**The ACT Equestrian Association Incorporated**

**Submission by the ACT Equestrian Association on the Development Application for the Duplication of William Hovell Drive #DA-202138722)**

*Figure 1 2021 Drawings for National Trail Underpass*

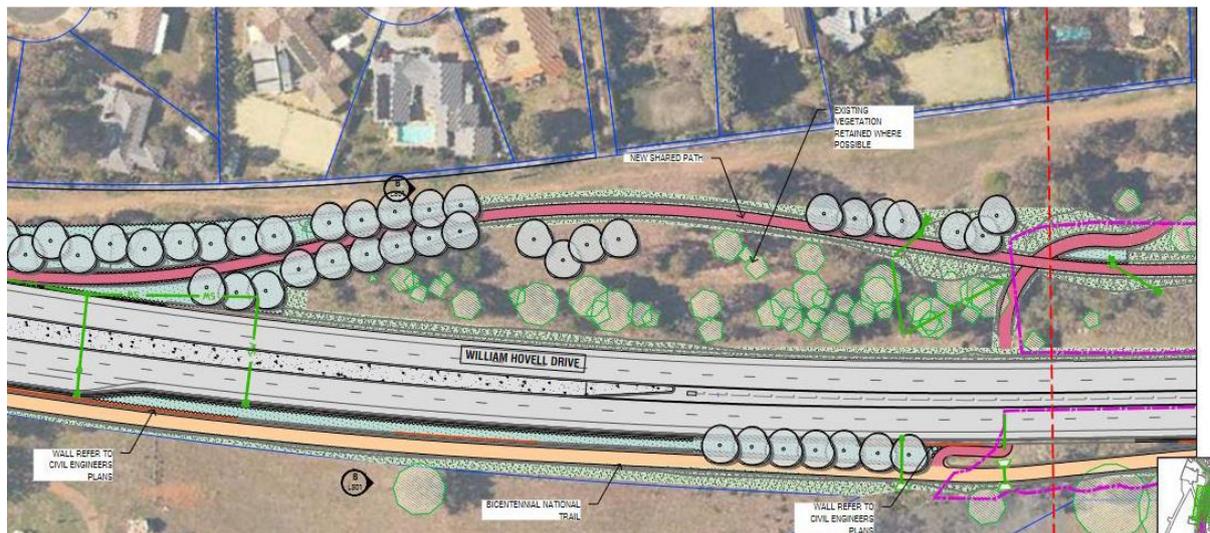
- the proposed upgraded vehicle access to the Lands End Cemetery would encourage cyclists to use the underpass, currently only accessed by horse riders, walkers and a small number of mountain bikes, as a short cut. No ameliorating design features were on offer. See *Figure 1*.
- it would be intersected on the Hawker side by a shared path running north-south through the greenspace between the William Hovell Drive and the back of Hawker, and

*In this drawing the upgraded cemetery access road is shown in orange and the existing National Trail route through the underpass is shown in the same red as is the proposed shared path on the eastern verge. It appears that from the outset the underpass was intended as a commuter path.*

- horses will have to mix with cars on the upgraded cemetery access with no verge and no speed mitigation arrangements. This is entirely inconsistent with *Active Travel Infrastructure Guideline Series 600*,
- the western approach to the underpass is a blind corner,

- the cemetery access road will be used as a rat run to the bike path on the other side of William Hovell Drive, and
- the eastern approach being very steep, fenced and concrete will make it extremely dangerous for any horse riders sharing the space with fast moving cyclists.

Figure 2 2022 Drawings for National Trail Underpass

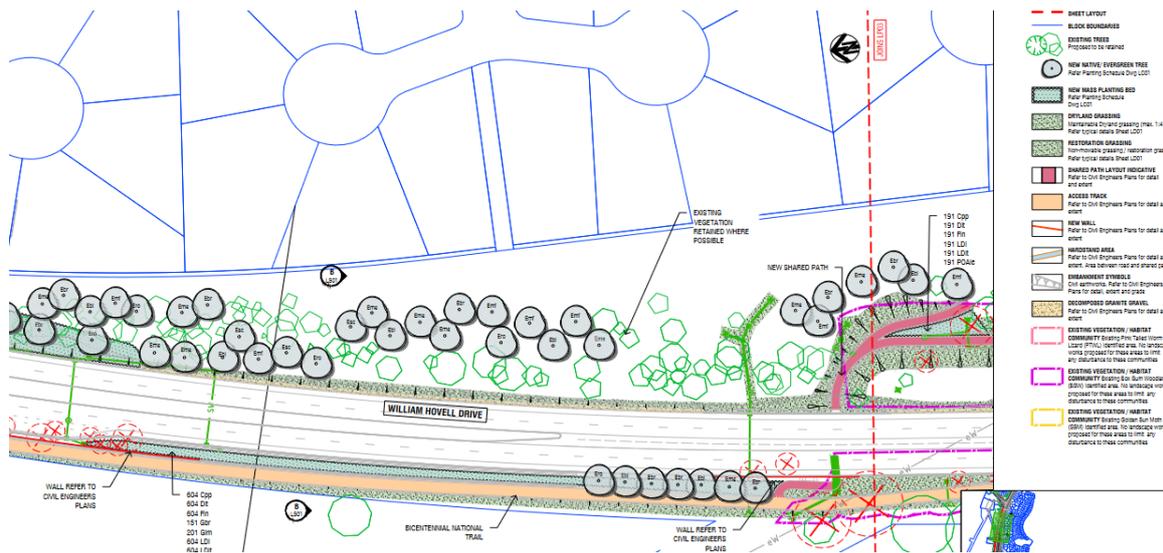
As a result of community consultation and objection by the residents of Hawker to a bike path through their dog off leash area, the shared path has now been entirely rerouted through the underpass – making it a certainty that fast-moving commuter bikes will be sharing a confined space with horses.

The new drawings for this section of the shared path (Figure 2) are extremely disturbing. Not only do they still show a completely blind western approach to the underpass, but they show that the shared path on the Hawker approach will merge with the eastern approach to the underpass out of an incised path with no indication of any measures to slow cyclists. Horse riders coming up out of the underpass could easily meet cyclists coming downhill at them at speed.

- The Cemetery Access Road should have a wide clear verge and speed humps to slow down vehicles
- The shared path should return to the eastern side of William Hovell Drive as originally proposed.
- Chicanes should be installed at a suitable distance from the underpass to slow down any fast-moving cyclists
- Horse mounting blocks should be provided on flat surfaces well away from the underpass.

Figure 5 Karma Stock Underpass 2022 Plan

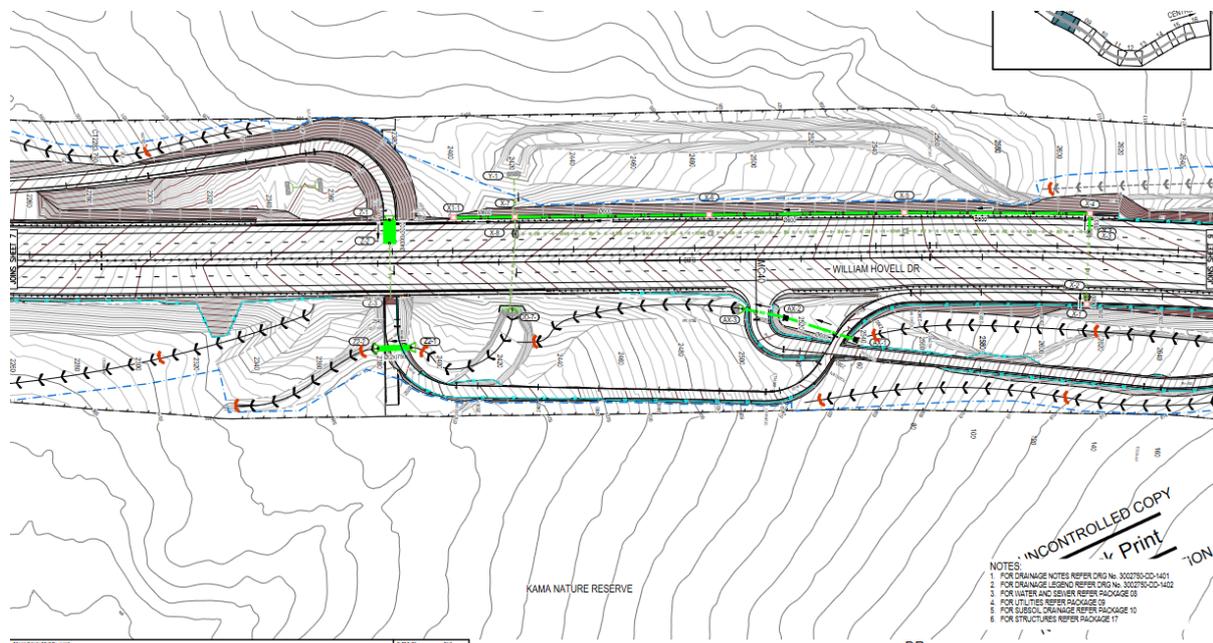
In this drawing the stock access path is visible as background to the proposed shared path route linking the southern extension to The Pinnacle Nature Reserve to the north and Karma Nature Reserve to the south. There are existing stock gates in the fence lines of both Reserves. There appears to be no provision for safely moving stock onto the shared path and through the underpass.

From the above drawing it is plain that there has never been any intention of connecting the stock underpass to the gate in the fence of The Pinnacle Extension. If anything, the design of the bike path has made what is currently a slight slope into an unnavigable obstacle. If this design is implemented there will be no clear, safe way to get cattle, let alone horses, across William Hovell Drive at this point.

**As a management necessity for the movement of grazing animals into the Karma Reserve, a safe access route should be shown in the plans for this section of the shared path.**
